ADDENDUM NO. 2

PROJECT NAME: South Stadium Video Booth
UNL PROJECT NUMBER: C502P001

DATE OF ISSUANCE: Monday, January 9, 2012
DATE OF BID OPENING: Thursday, January 12, 2012

POWER PLAN - UPPER LEVEL

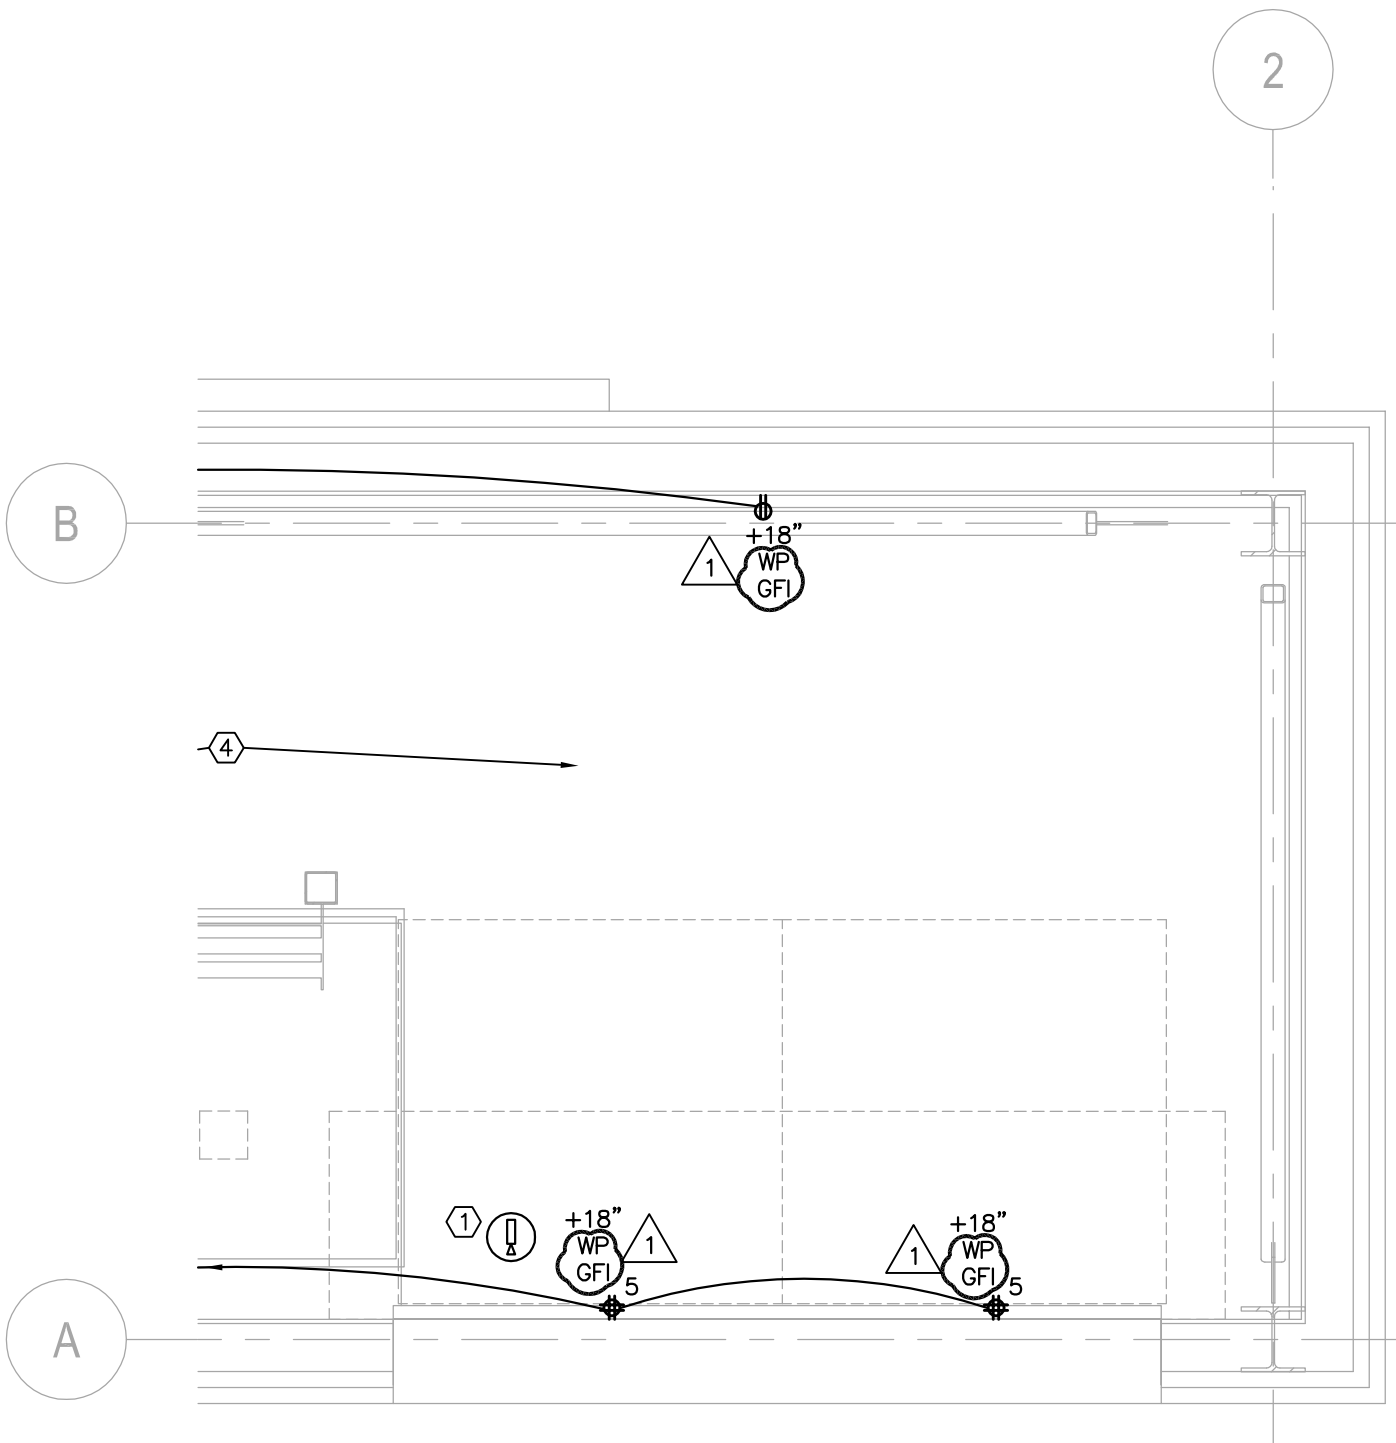
1. One Line Diagram 1 / E1.1 – Revise Note #3.
2. POWER PLAN-UPPER LEVEL : 2-Pole GFI Breaker andOutlets

SITE PLAN • SCHORR CENTER

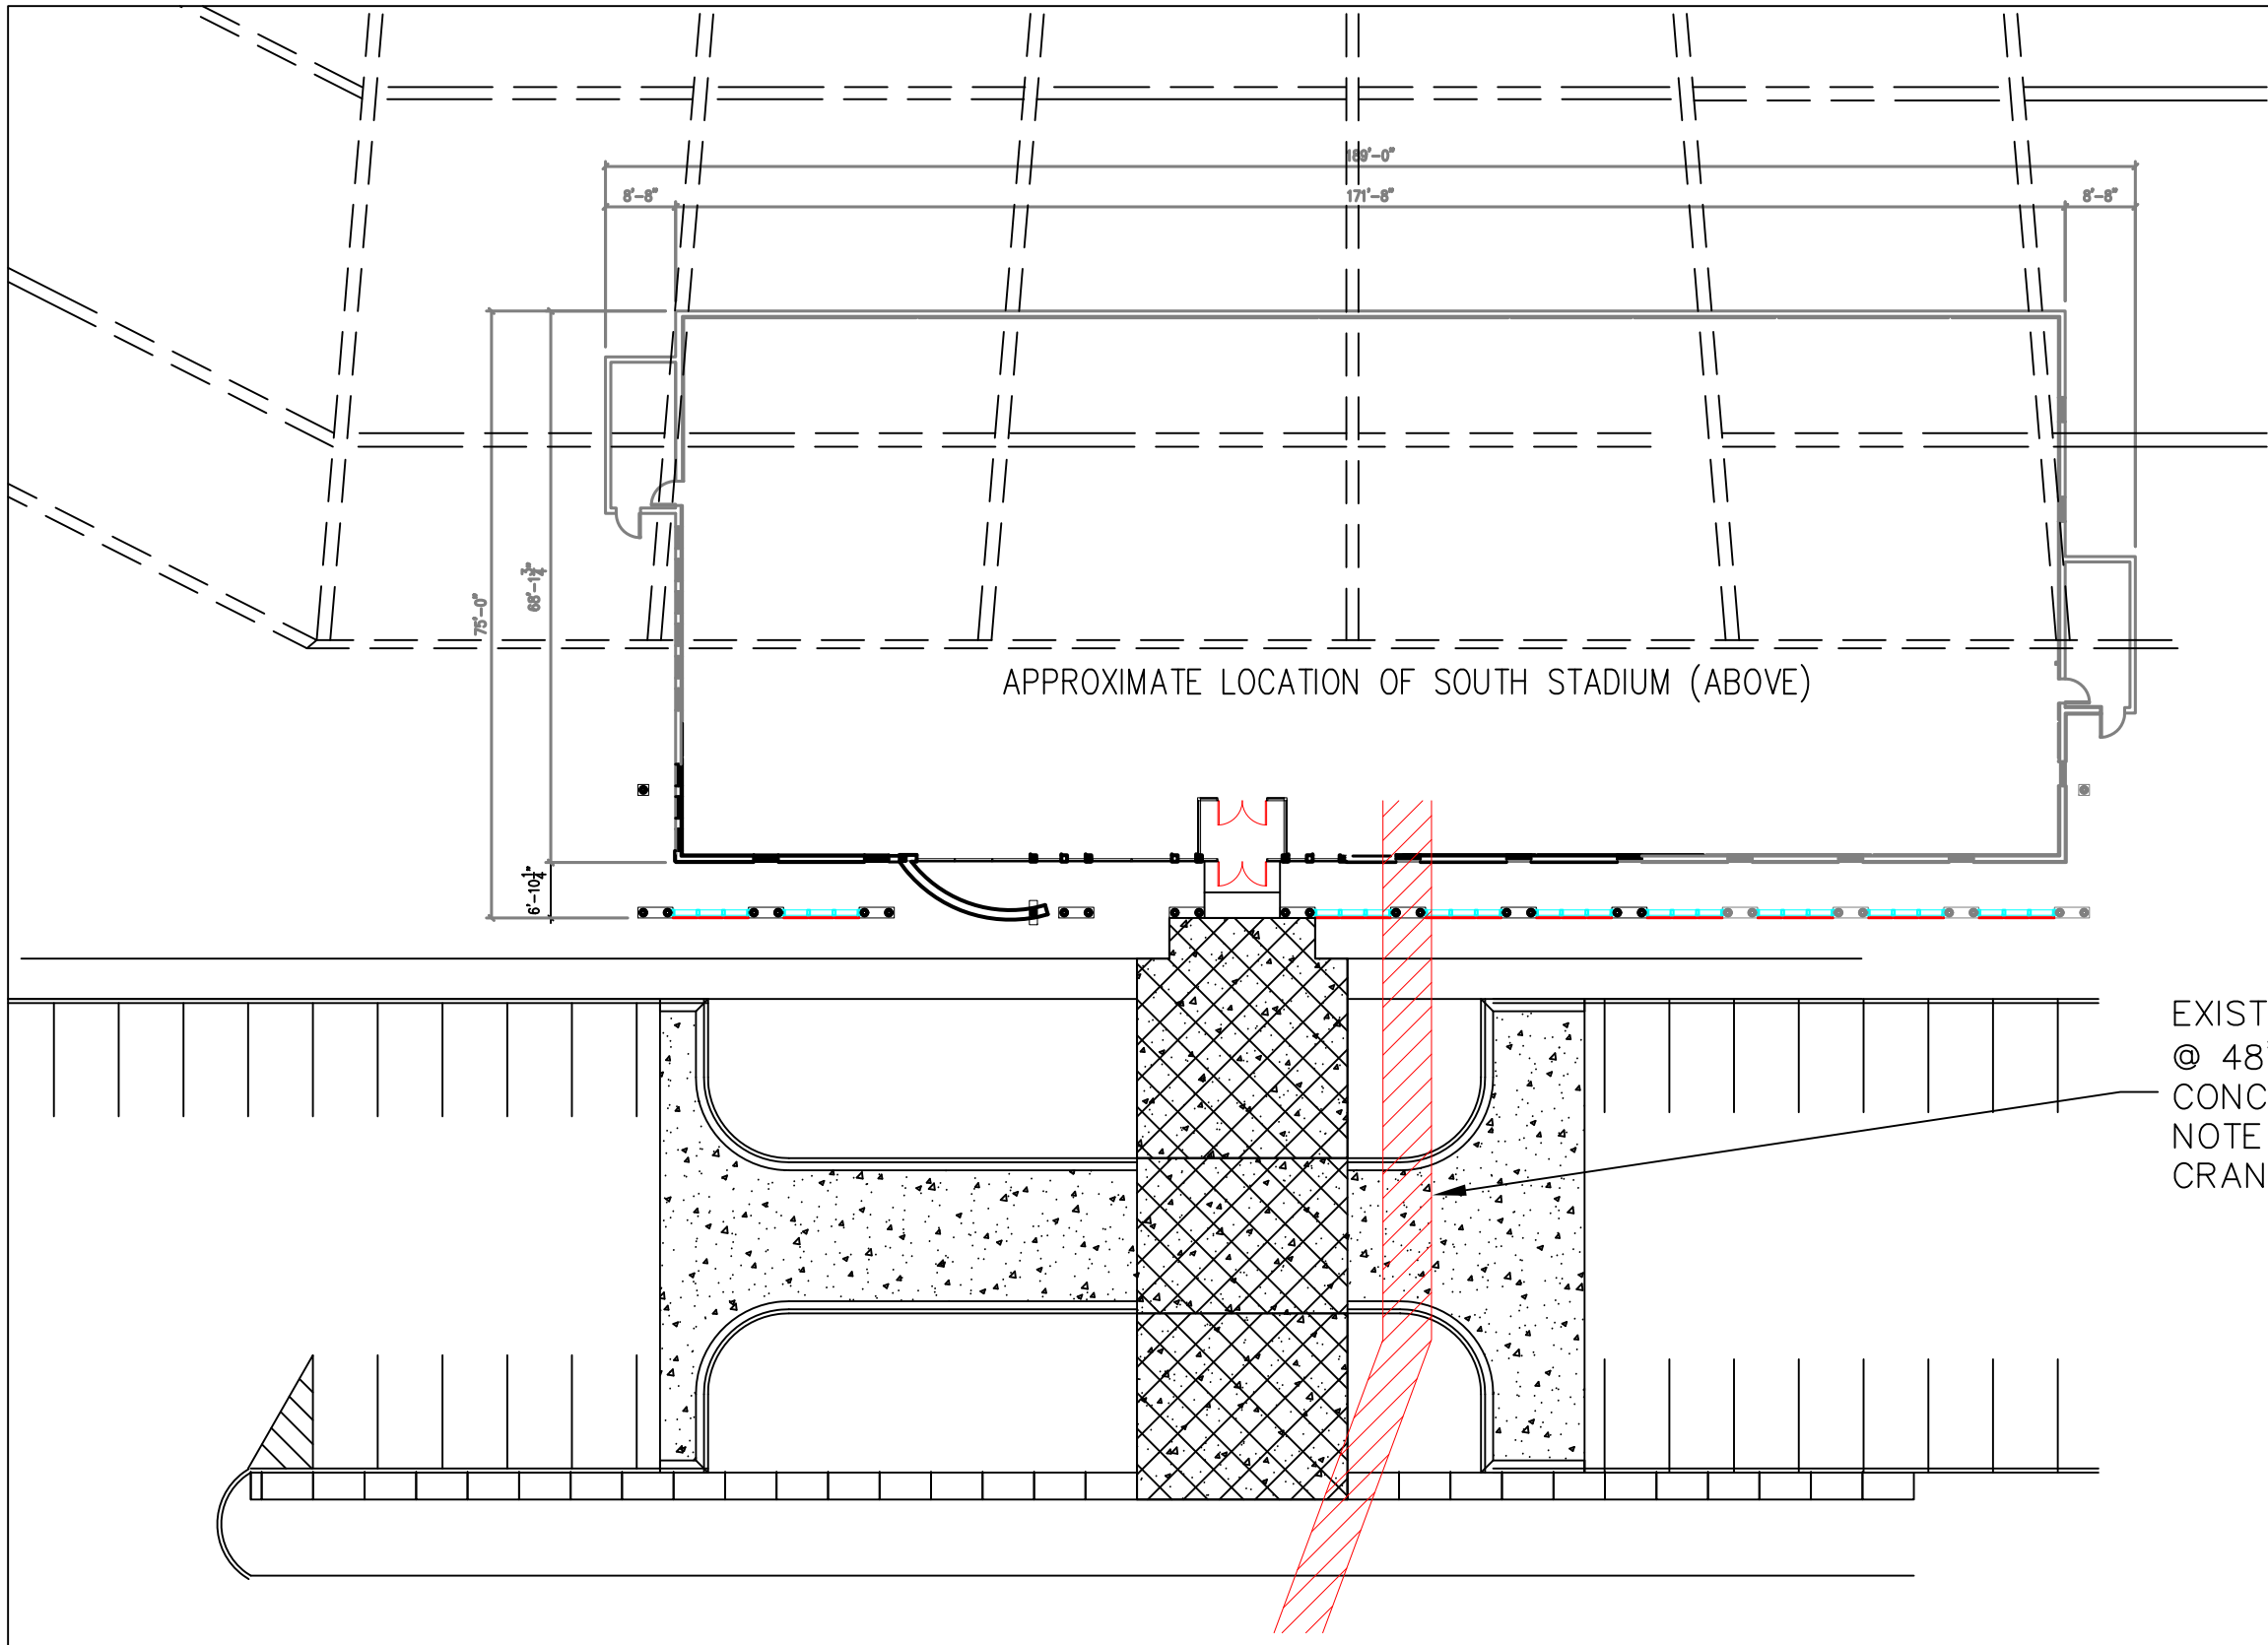
4. QUESTION: Are there any existing underground utility tunnels that may affect the placement of a crane?
ANSWER: YES, there is a steam tunnel that must be taken into account. See attached plan UNL3 below for location.

EXISTING 6' WIDE STEAM TUNNEL @ 48" BELOW GRADE. PRE-CAST CONCRETE ARCHED CONSTRUCTION, NOTE TUNNEL WHEN STAGING CRANE AND OUT-RIGGERS.
